# *Florence County Government*

### **ADDENDUM NO. 2 - FRIENDFIELD FIRE STATION (BID NO. 2-16/17)**

CONSTRUCTION PLANS  
FOR:  
**HANNAH-SALEM-FRIENDFIELD  
FIRE DEPARTMENT  
NEW STATION AT FRIENDFIELD**

CLIENT:	HANNAH-SALEM FRIENDFIELD
PLAN SET:	FIRE DEPARTMENT
DESCRIPTION:	NEW STATION AT FRIENDFIELD
DESC:	DETAILS & SCHEDULES
DATE:	Jul 21, 2016
PROJECT:	AE055
SHEET:	A4.0

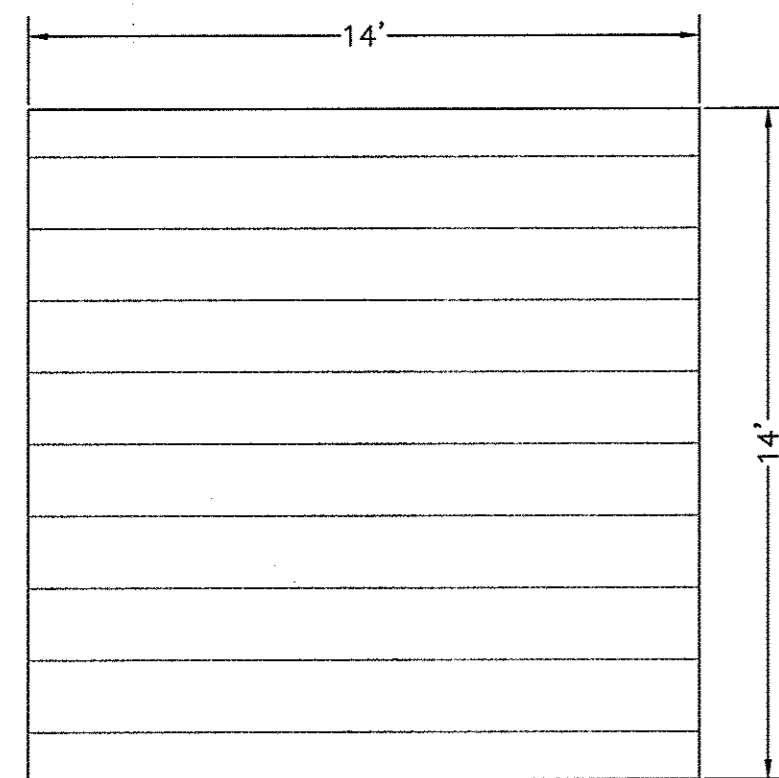
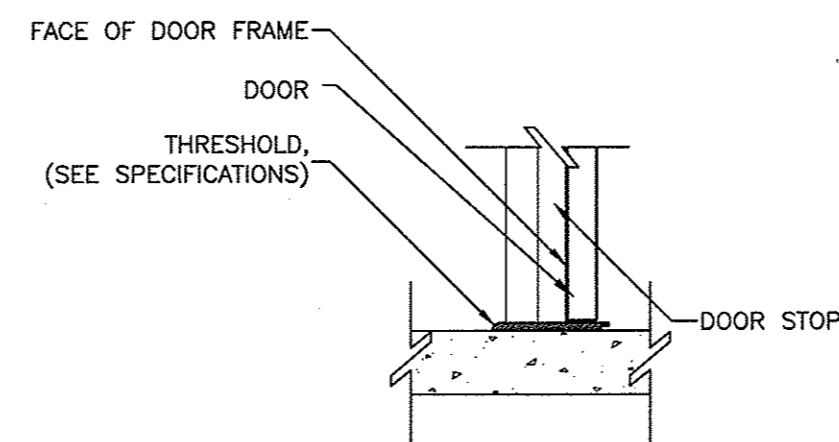
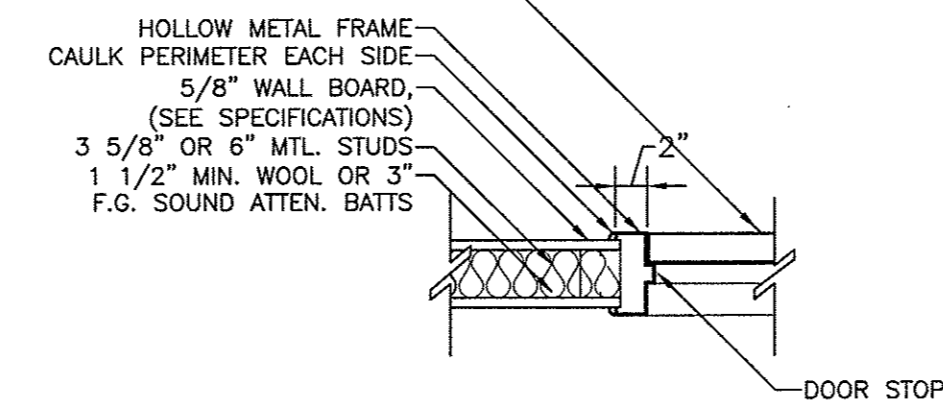
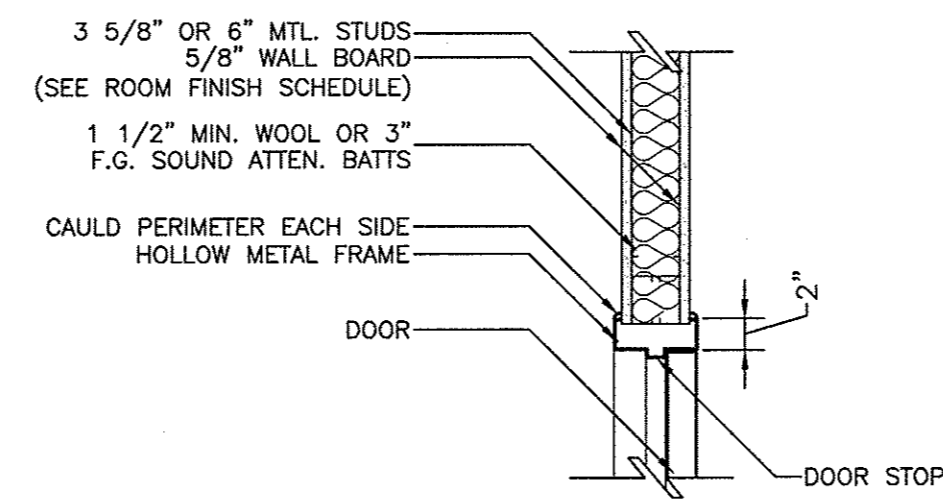
| Sheet A4.0 | The colors are specified for walls and doors.                                                                                                                                  |

DESCRIPTION:	WALL SECTIONS
DATE:	07/21/16
PROJECT:	AE055
SHEET:	A6.0

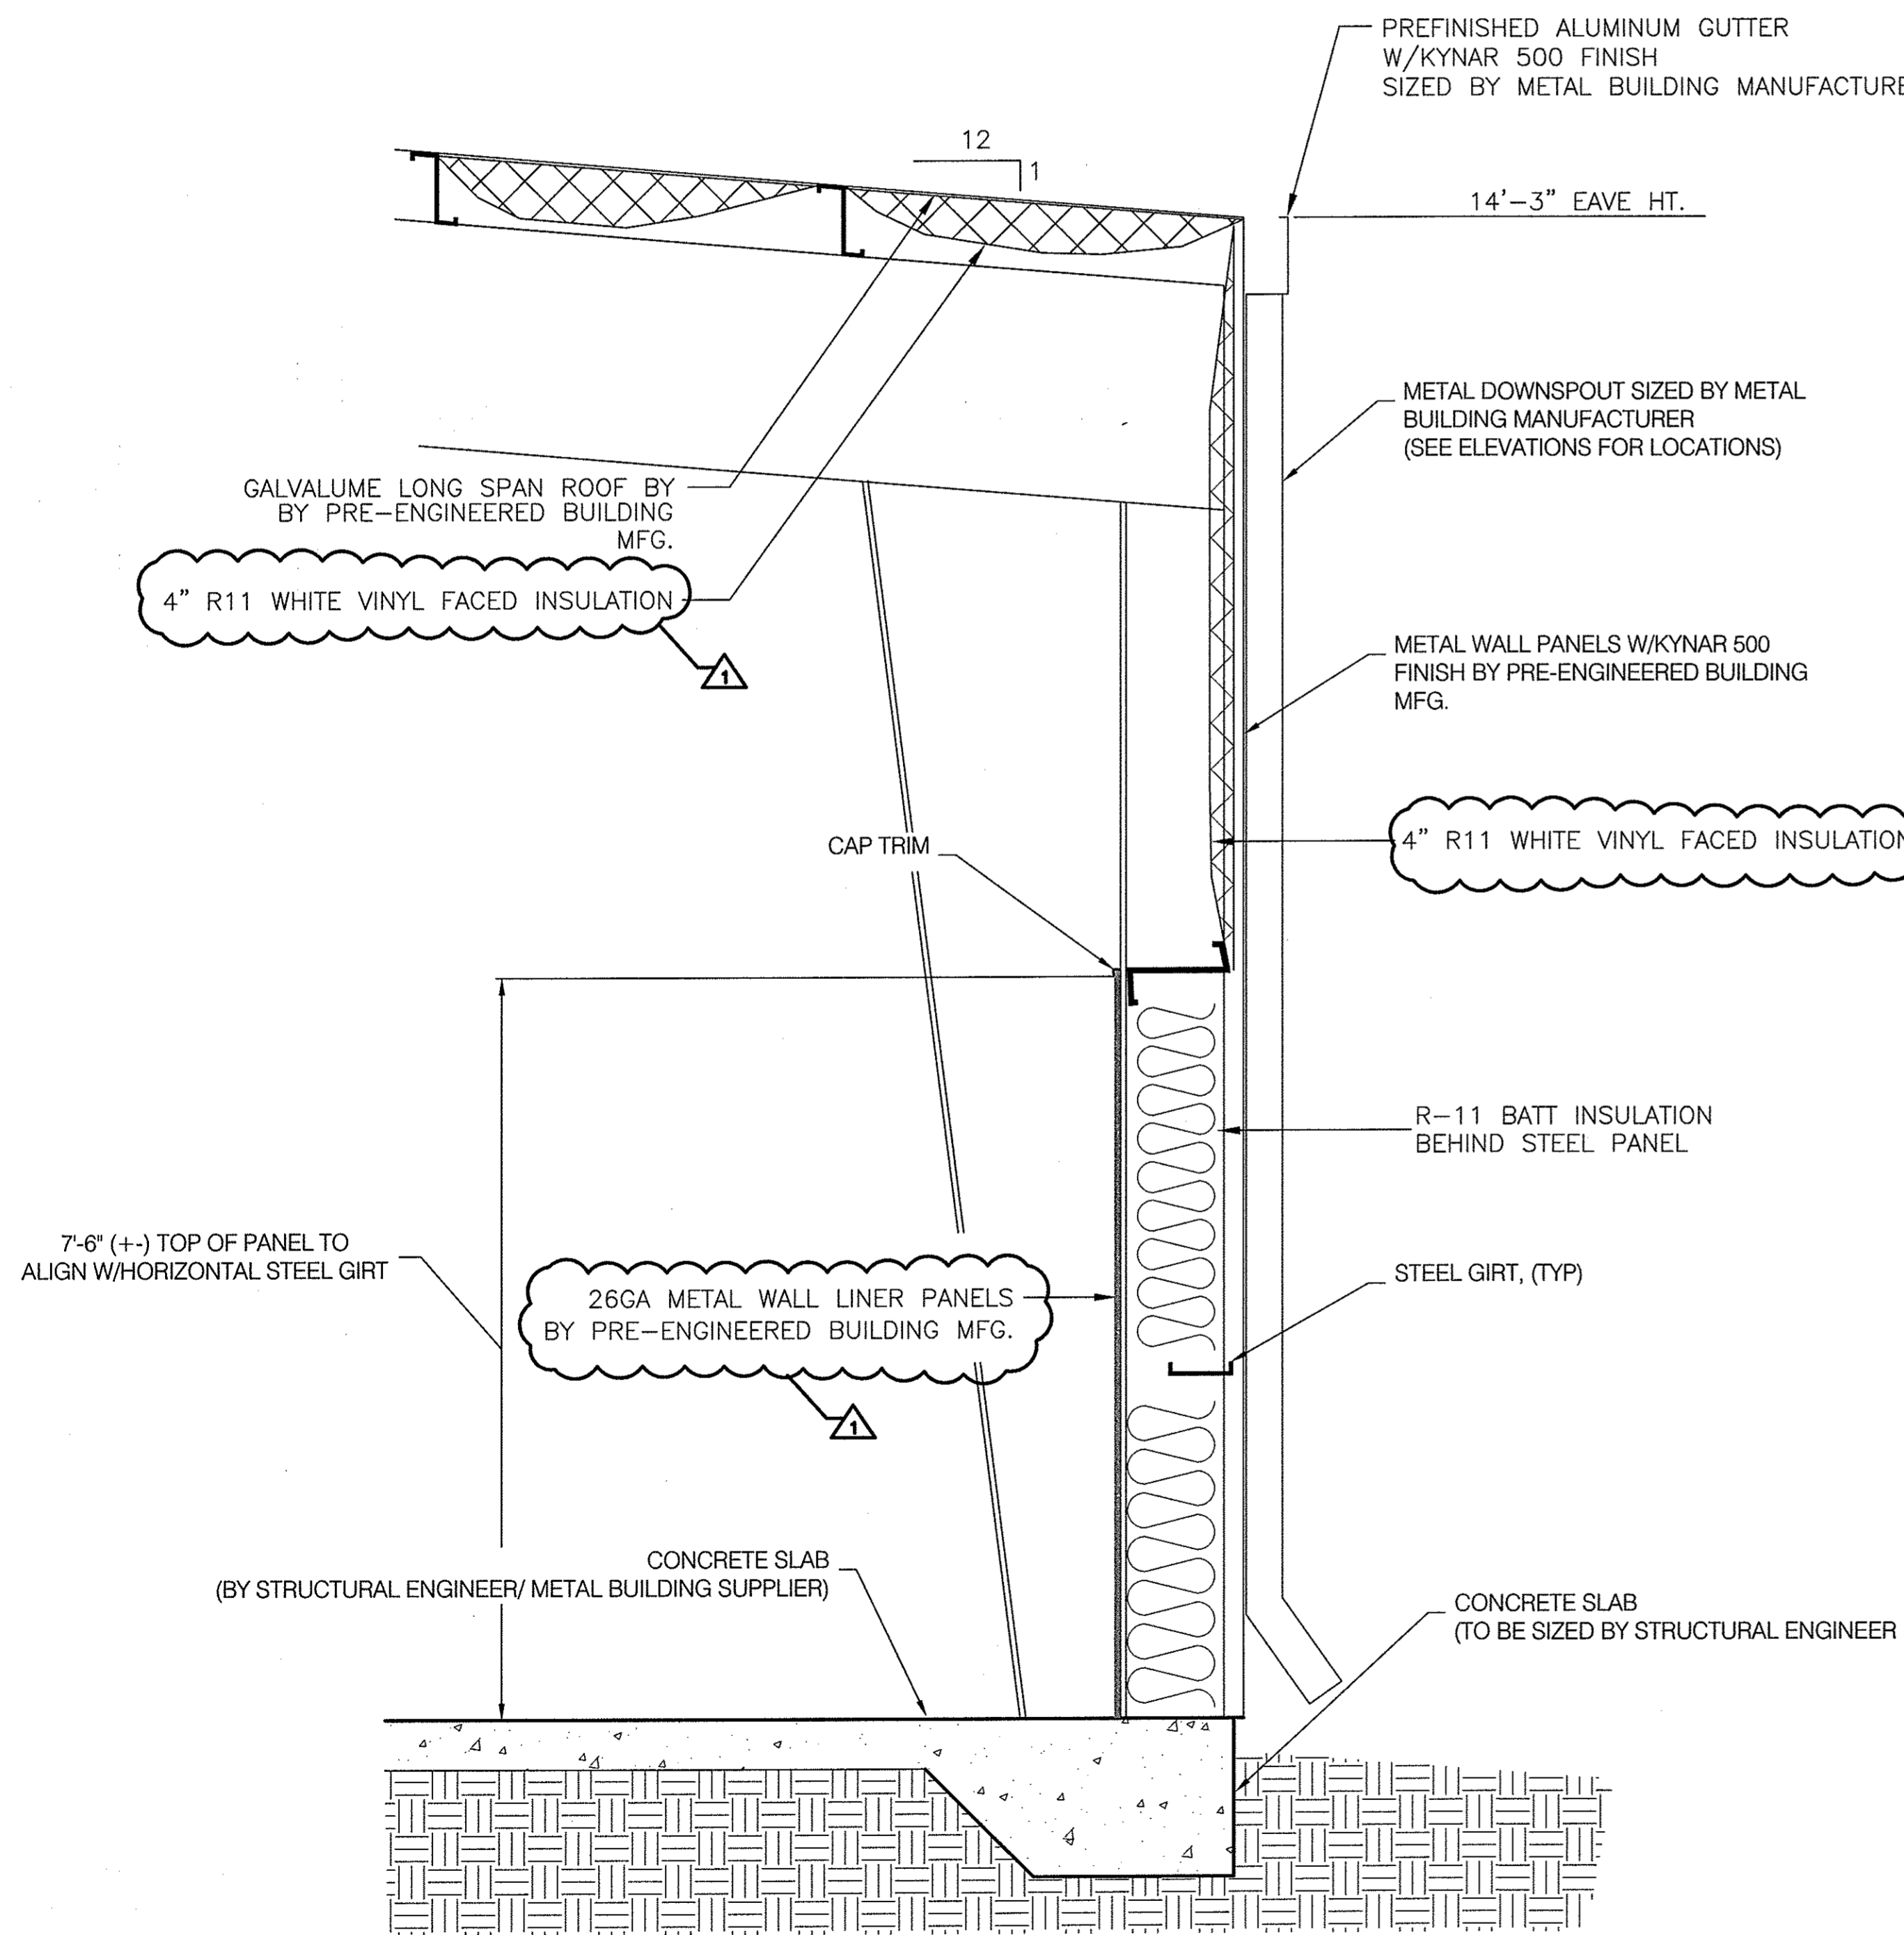
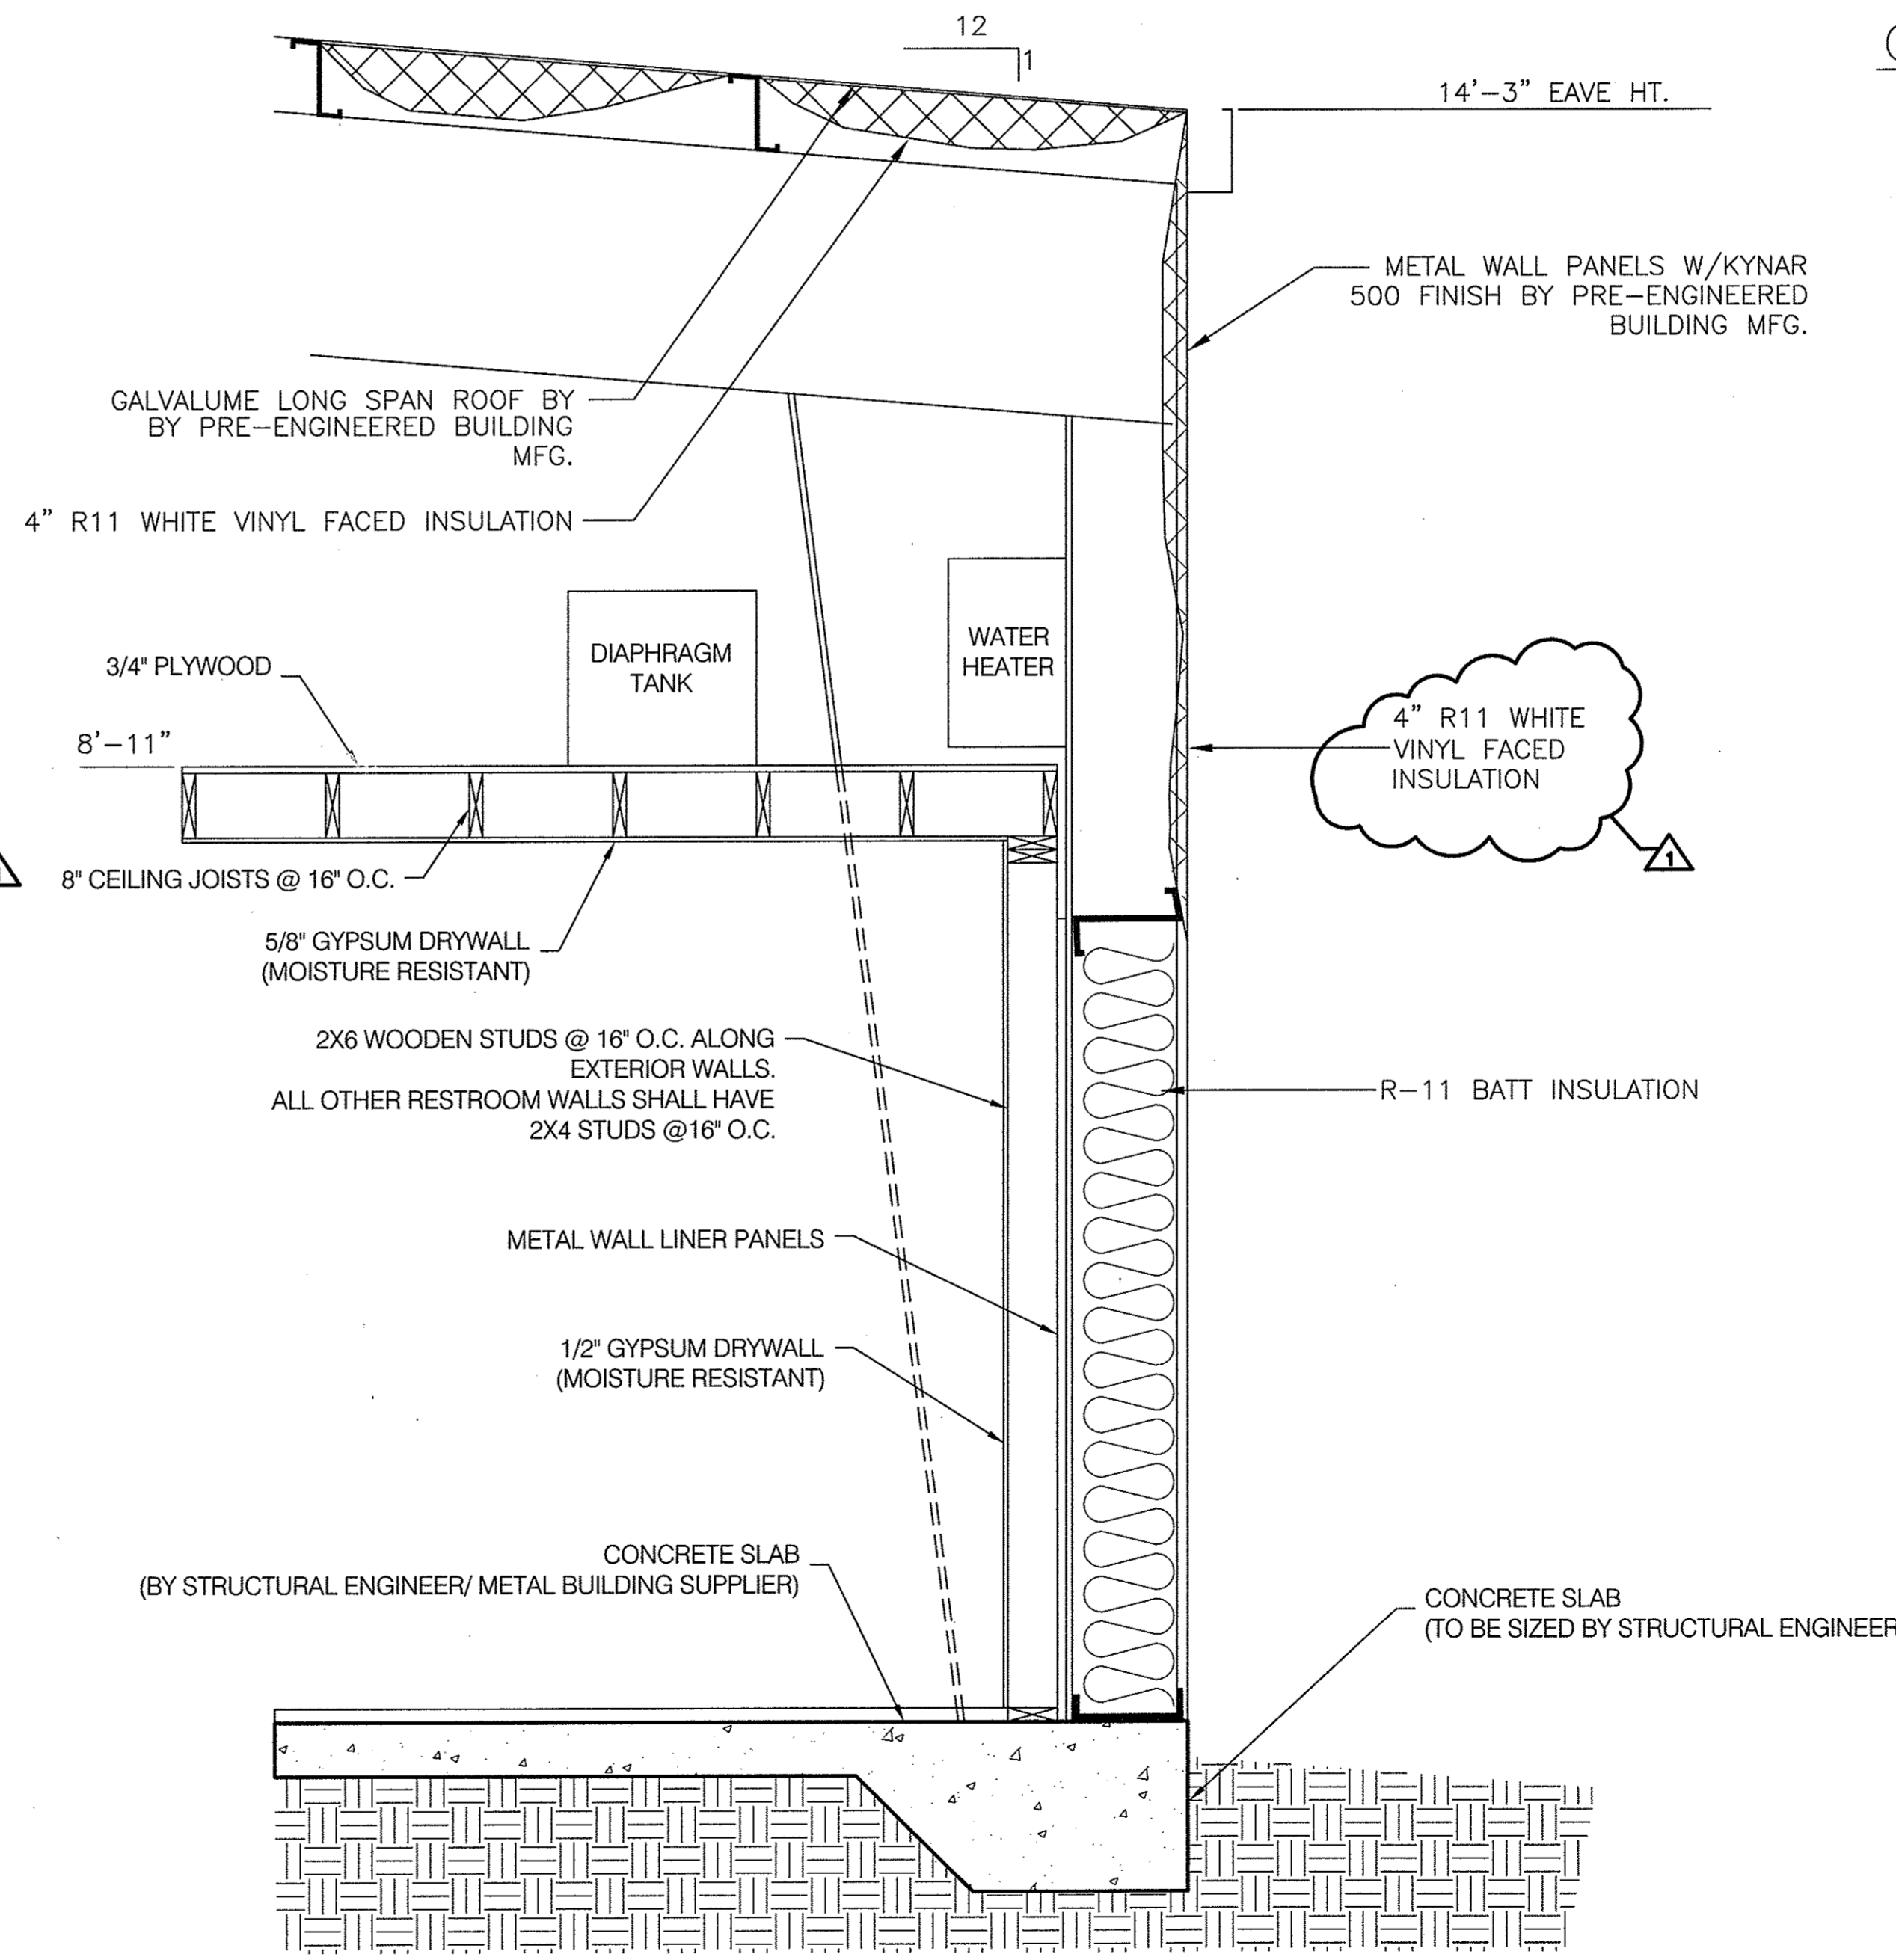
- Sheet A6.0 The insulation on the ceiling and walls above the liner panel will be 4" R11 white vinyl-faced insulation.
- Sheet C2.0 Added more gravel to allow the fire trucks to turn around without entering the road.  
Added striping, stop bar and stop sign (yes, a stop sign) to apron.

POWER RISER - BASE BID  
NTS

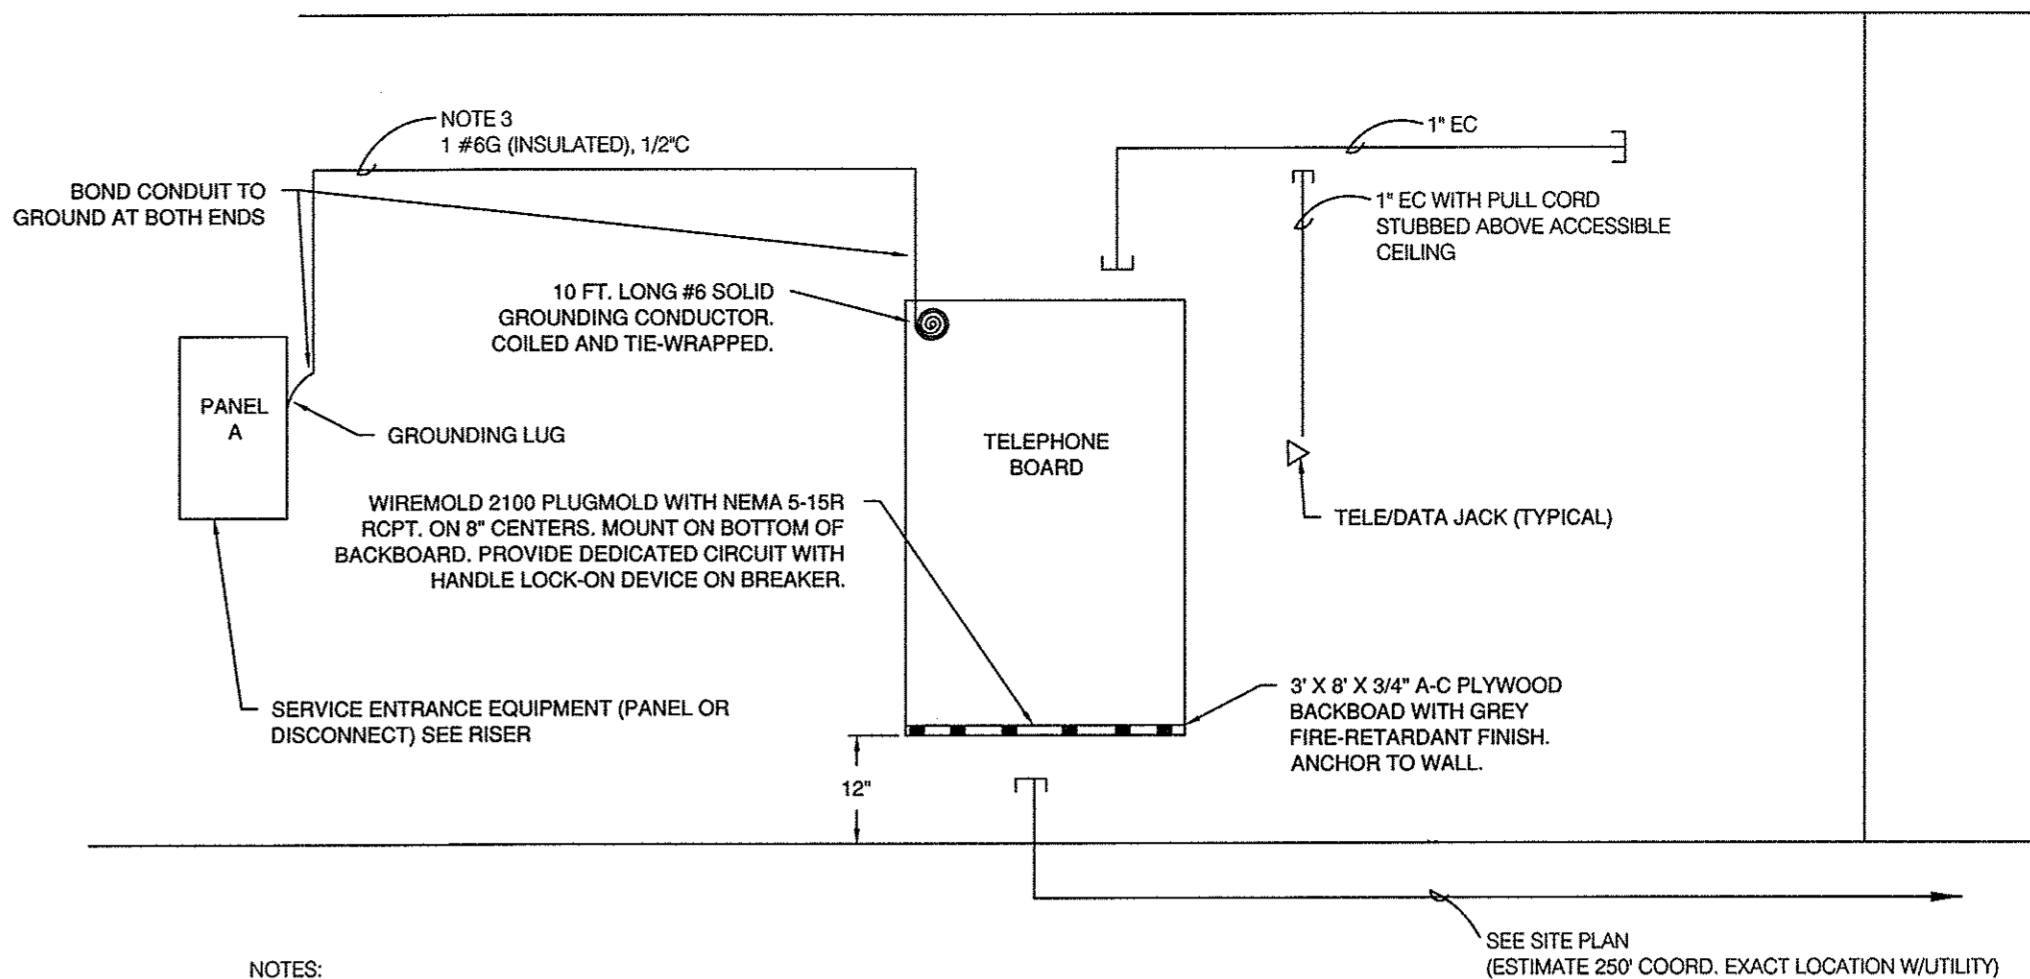
4. Is an expandable endwall required at column line 3 at A1.0? **No, we will use a standard endwall.**
5. On the riser diagram it shows (2)4-350KCMIL, 3-1/2"C, this is typical of a 600A 3 phase service. The disconnect transfer switch and panel A are all single phase 200 Amp. Can we get clarification as to if this is an error? **Yes, this was an error, and it is corrected in the updated plans. The service is 200 Amp single phase.**

- Sheet E3.0 Corrected the service lines per Item 5 above.
- Sheet E4.0 Moved the junction box on IFH-1 to the front of the building.  
Shifted HB-1 lights to avoid conflicts with IFH-1 & the overhead doors.  
Added locations of the OB lights (outdoor spotlights).
